Model: Cattleya		Date: 30-Jun-99	No.: MA257001
Modified Article: Silicone oil		Prepared by: H. Matsui	
From: Technical Service Dept., GTS Division			
Reason for Modification:	☐ Parts catalog correction ☐ To facilitate assembly ☐ Part standardization	☐ Vendor change ☐ To improve reliability ☒ Other	☐ To meet standards ()

Model: Cattleya		Date: 15-Aug-99	No.: MA257002
Modified Article: Main Board and Scanner IPU Board		Prepared by: H. Matsui	
From: Technical Service Dept., GTS Division			
Reason for Modification:	☐ Parts catalog correction ☐ To facilitate assembly ☐ Part standardization	☐ Vendor change ☐ To improve reliability ☒ Other	☐ To meet standards ()

Model: Cattleya		Date: 30-Apr-99	No.: MA257003
Modified Article: Timing Belt		Prepared by: H. Mastui	
From: Technical Service Dept., GTS Division			
Reason for Modification:	☐ Parts catalog correction ☐ To facilitate assembly ☐ Part standardization	☐ Vendor change ☒ To improve reliability ☐ Other	☐ To meet standards ()

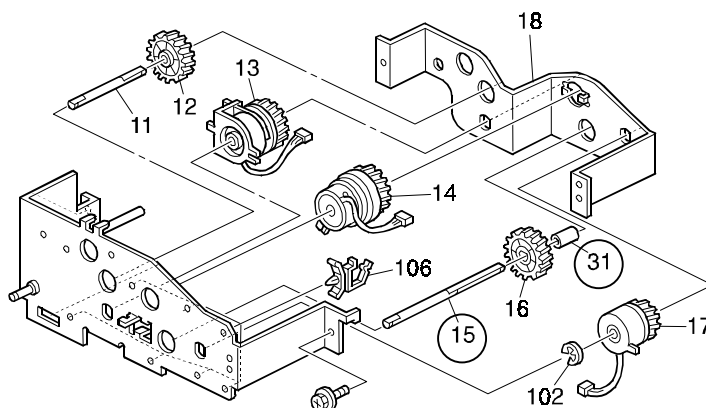
The development output gear has been changed in order to eliminate the possibility that the bottom of the gear groove touches the teeth of the engaged gear. This is to reduce the occurrence of banding which may appear on copies/print outs at 1.65 mm intervals.

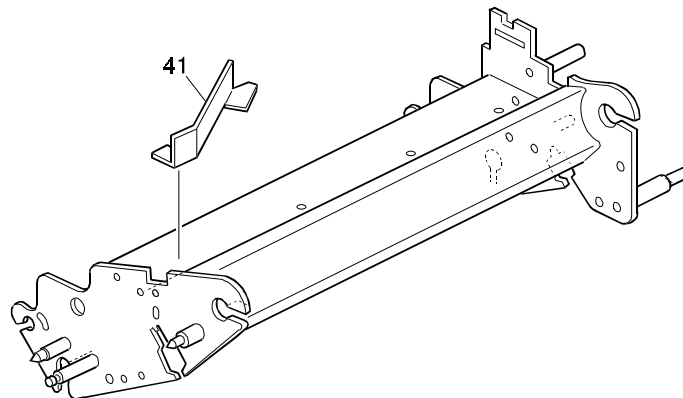
In order to prevent SC452 (Belt mark detection error) which leads to the "image shift" problem, the following part has been newly added. This mylar prevents the belt mark detection sensor from getting dirty with toner dust.

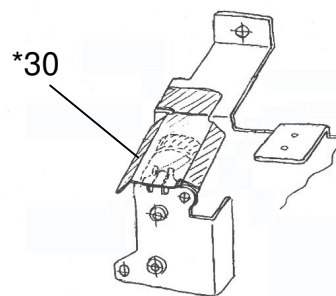
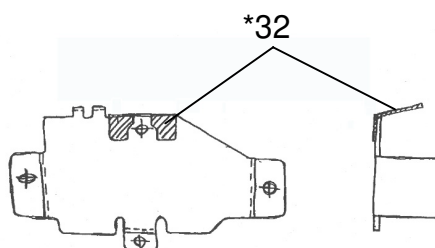
To prevent any foreign particles from dropping onto the ITB cleaning shift clutch and PTB shift clutch, mylars have been added.

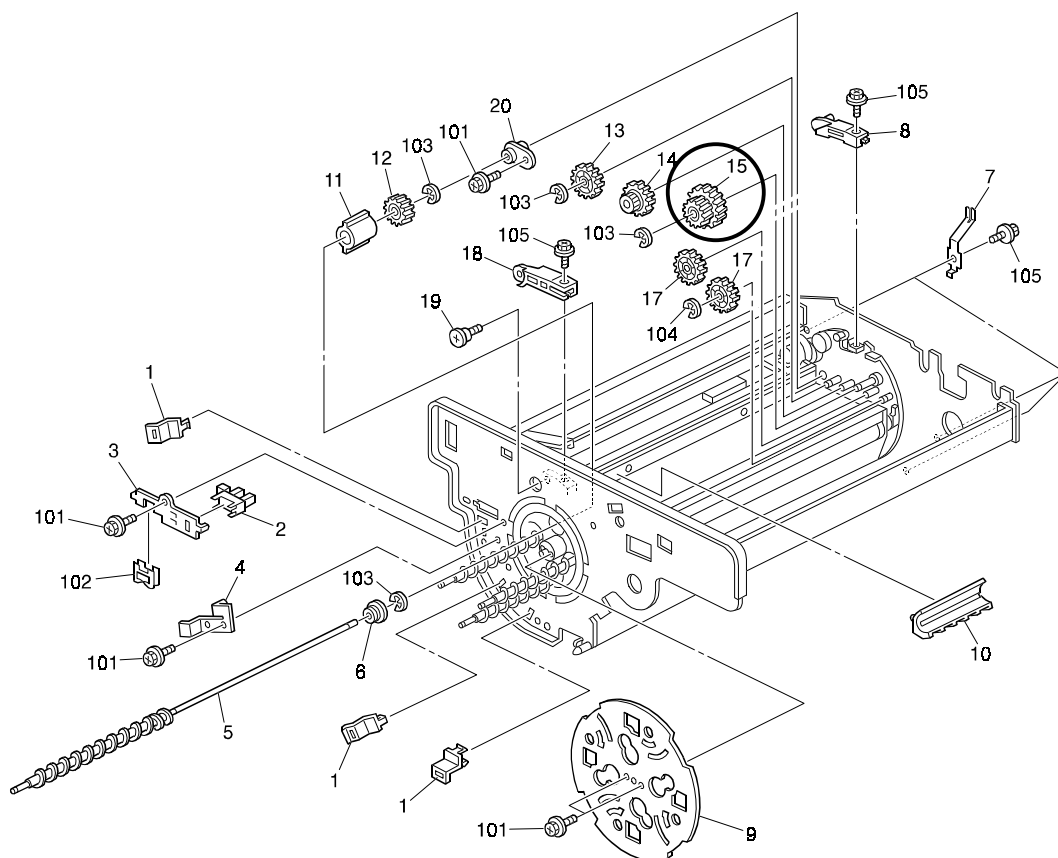
As a countermeasure for the 1.65mm interval banding, two development drive gears have been changed to one molded part.

Page 24:

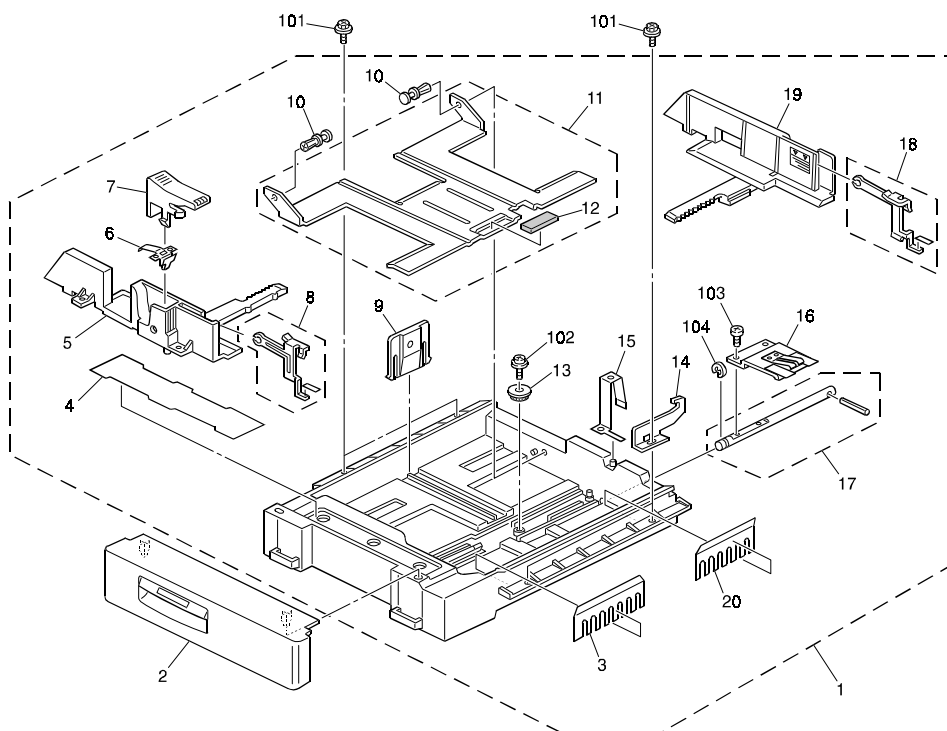
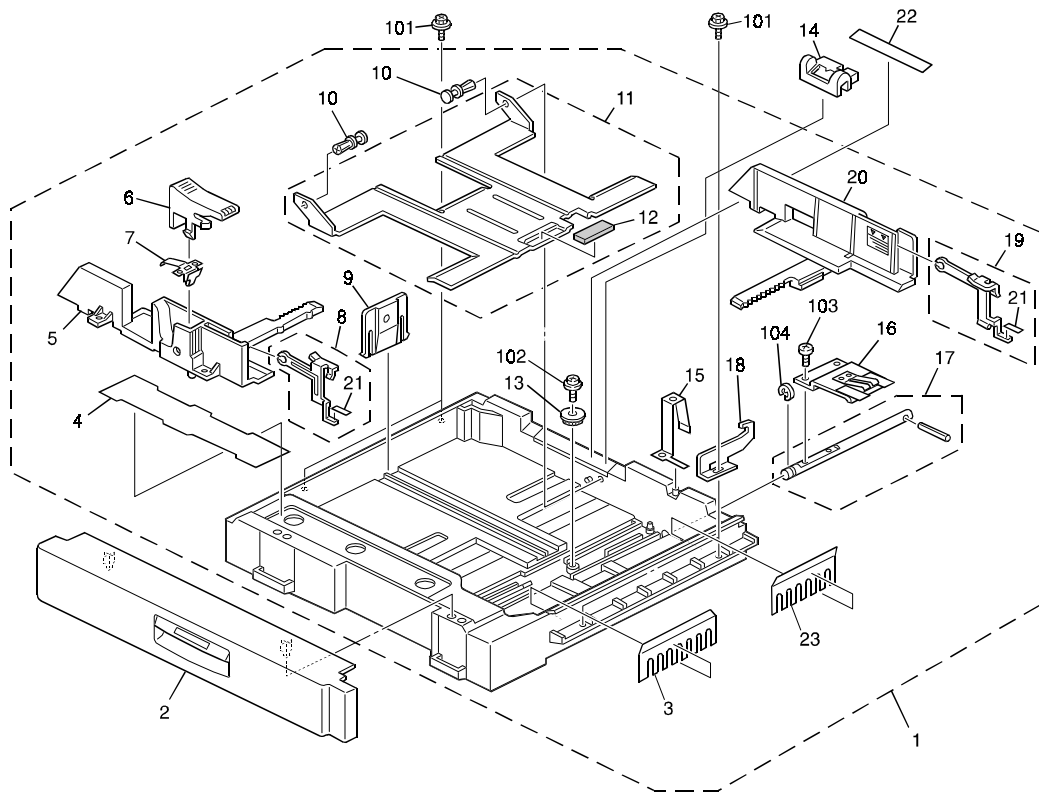
Please replace the illustrations with the following correct ones:

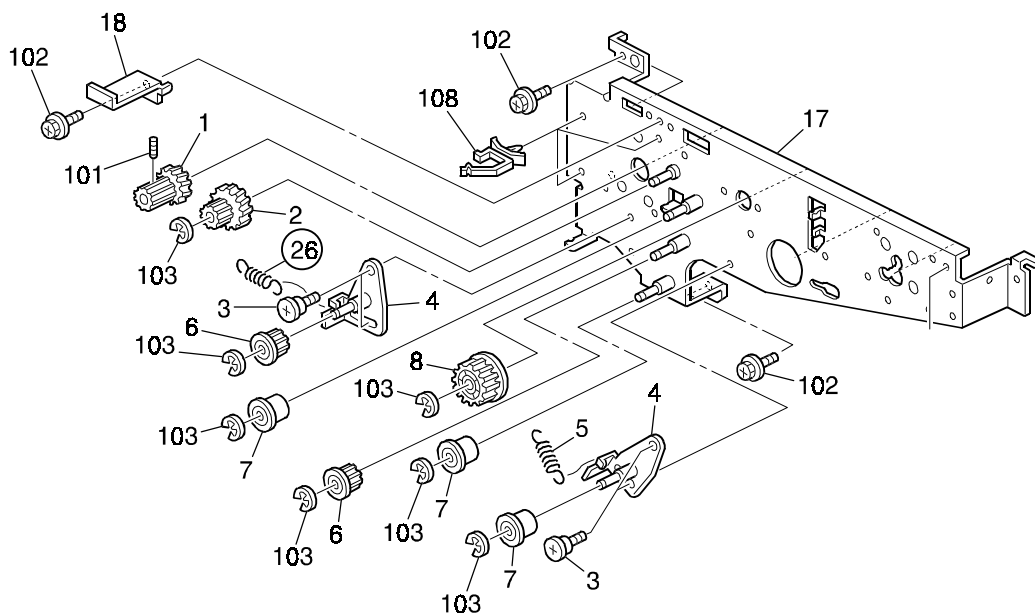
To ensure proper tension of the timing belt for development drive, the tightner spring has been changed.

Illustration on page 72

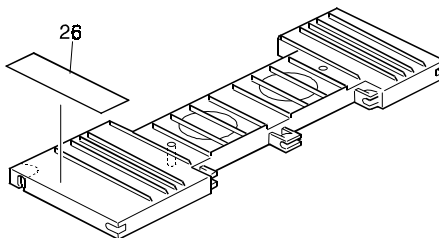
The lower entrance guide plate for the fusing unit has been modified. This modification prevents the jitter at 355mm and/or 365mm from the leading edge in thick or extra thick paper mode. With this modification, decal A2574245 has been newly added. Please refer also to the related RTB #RA257023 issued on December 15, 1999.

Illustration on page 82

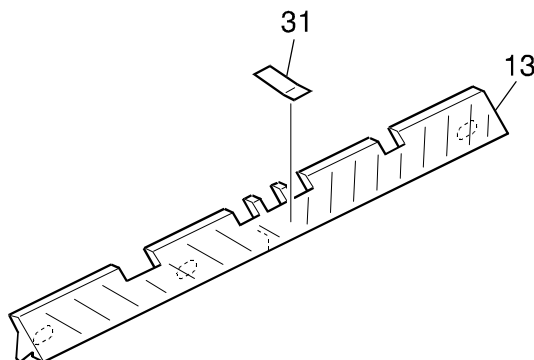
The above mylars (two types) have been newly added. These mylars prevent winding jam at the fusing roller. Please refer to the related troubleshooting RTB (#RA257029) which shows you where to attach these mylars in more detail.

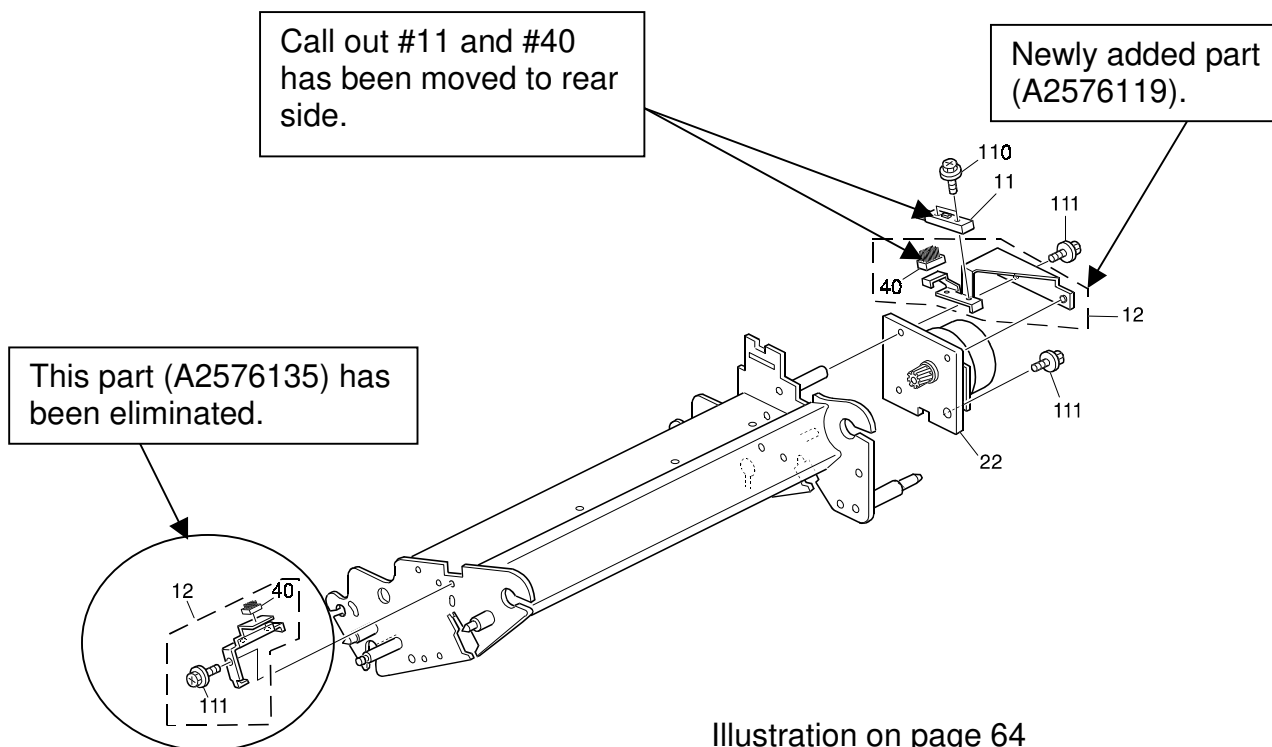
The positioning sensor holder ass'y has been changed to A2576119 and moved from the front side to the rear side of the ITB (image transfer belt) unit. This is to move the belt mark sensor (call out #11) to the rear side of the ITB unit. Please refer also to the related RTB #RA257030, which shows you the aim of this modification and the position for assembly in more detail.

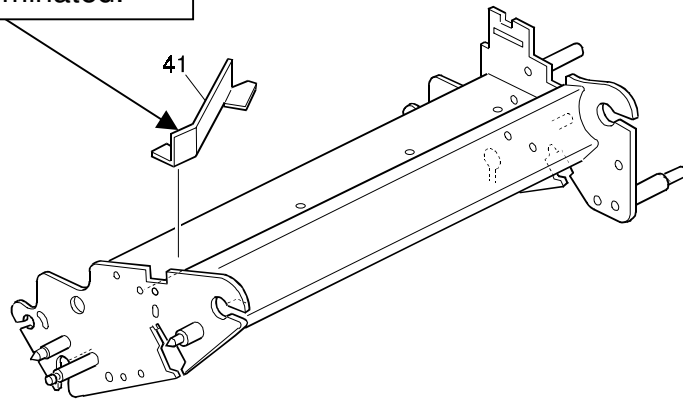
This mylar (A2576137)
has been eliminated.

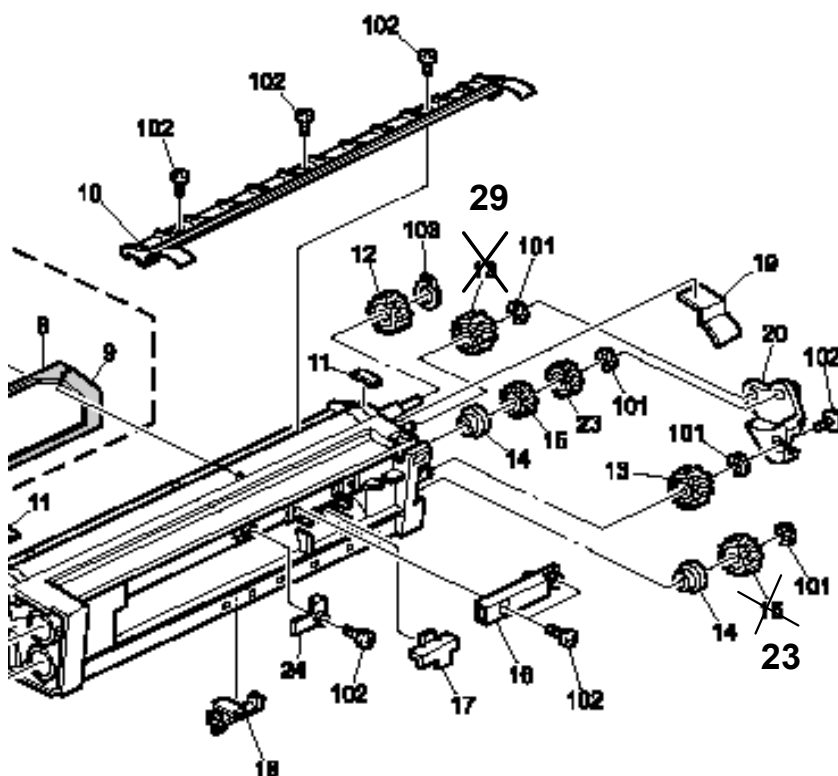
Please make the following correction in your parts catalog. Also, please correct the index numbers on page 50 of your parts catalog as shown in the diagram below.

New illustration on page 48

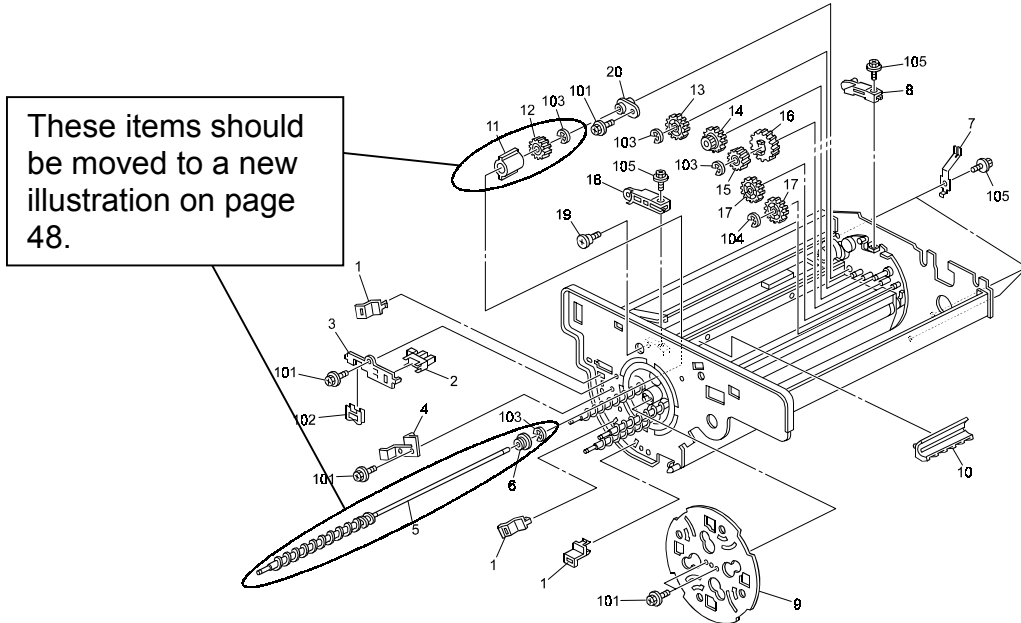
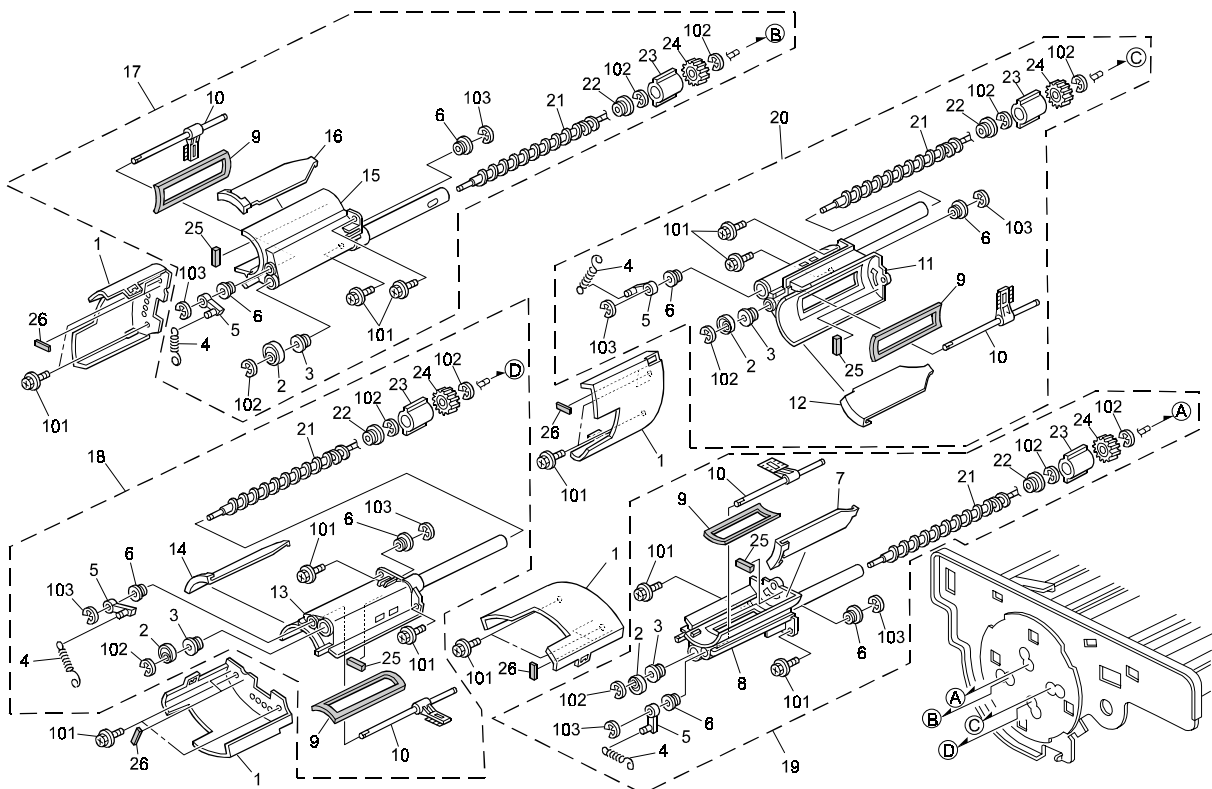
The P/N for the toner hopper assemblies (K, Y, C, and M) has been changed as shown in the table above. This was a result of modifications made to improve the ease of turning the toner cartridge. Specifically, the corners on one end of the shutter have been cut off and the ribs have been rounded. As a result, the shutter will not catch on the ribs even when it receives the twisting force from cartridge rotation.

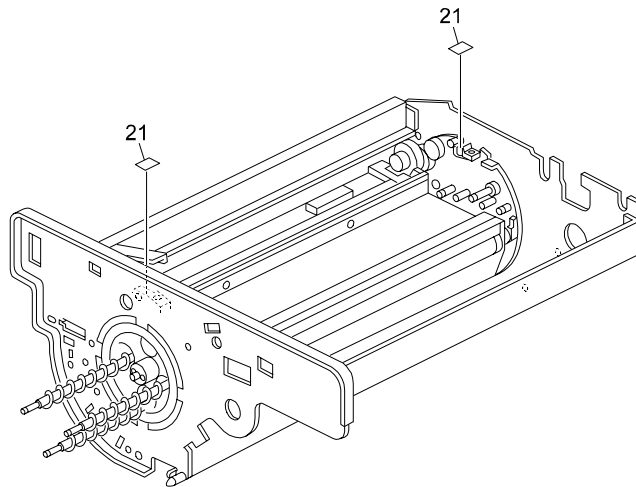
The interchangeability of the development unit itself is X/X. However, by attaching the PG seal (A2573224) on the development unit supporter and adjusting Vref at the same time, the interchangeability will be X/O. This procedure is mentioned in RTB#RA257035.

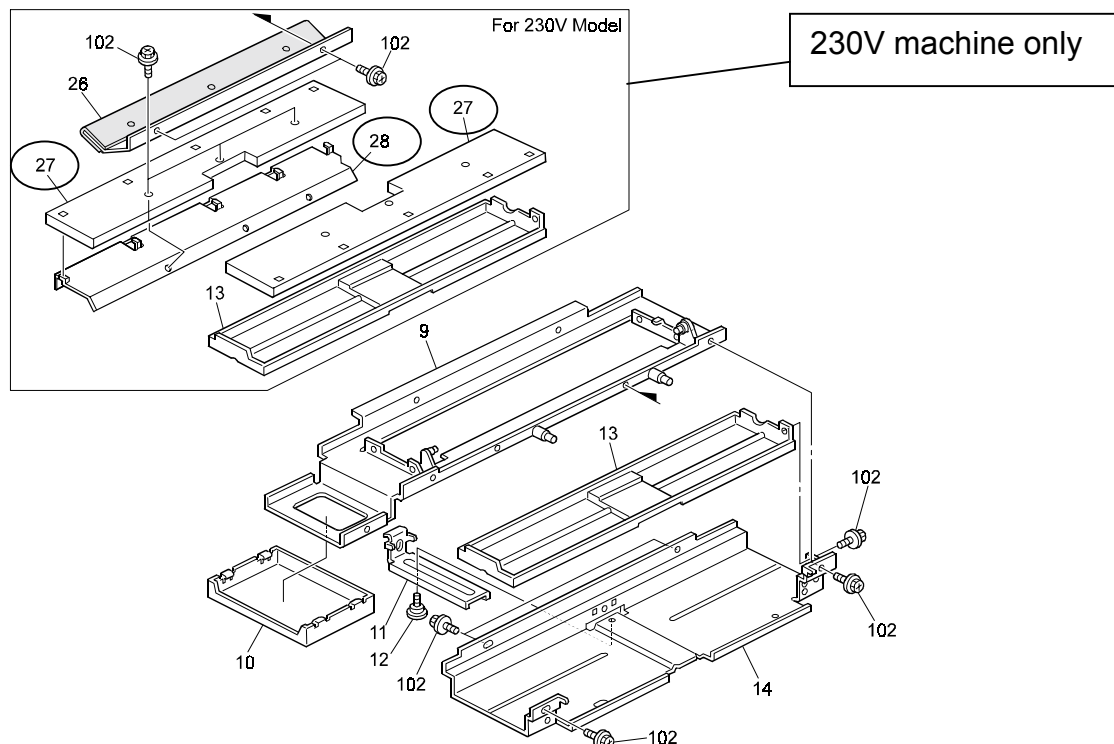
As a countermeasure to oil leakage, the oil pan felt and bracket oil pan felt have been newly added as shown in the above table. One pad is attached to the oil pan itself, and the other is attached between the pressure roller oil supply pad and the oil pan pad.

The two new pads will absorb the fusing oil collected by the pressure roller blade. When the amount of oil on the pressure roller surface becomes low, the oil absorbed by the pads will be supplied to the pressure roller via the pressure roller oil supply pad. The pressure roller surface has a relatively low amount of oil when the paper is passing through the two fusing rollers.

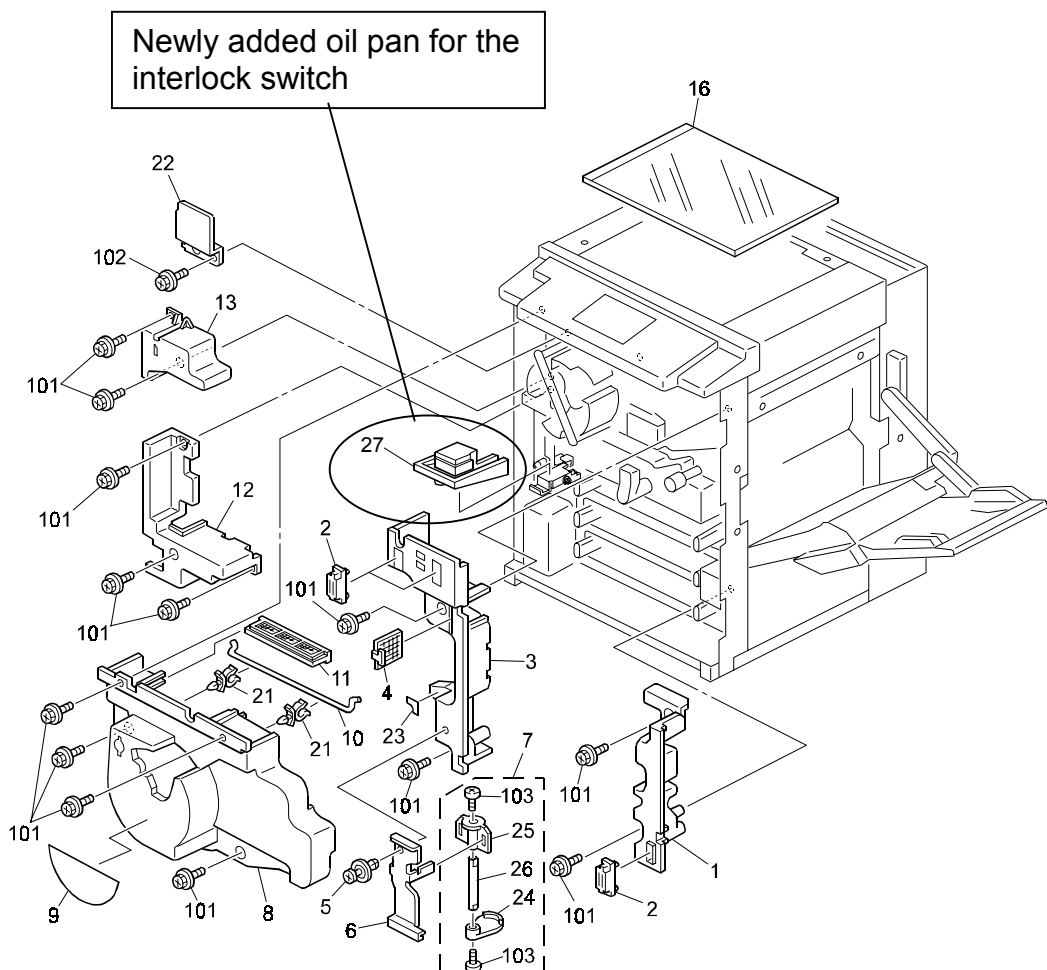
An oil pan for the interlock switch has been newly added with the above P/N. The pan has been attached to the bracket located above the interlock switch.

This will prevent any oil dripping down from the fusing unit from getting on the interlock switch. This has been done because if enough oil were to accumulate on the switch, in the worst case, a spark from the switch contact points may ignite the oil inside the switch.
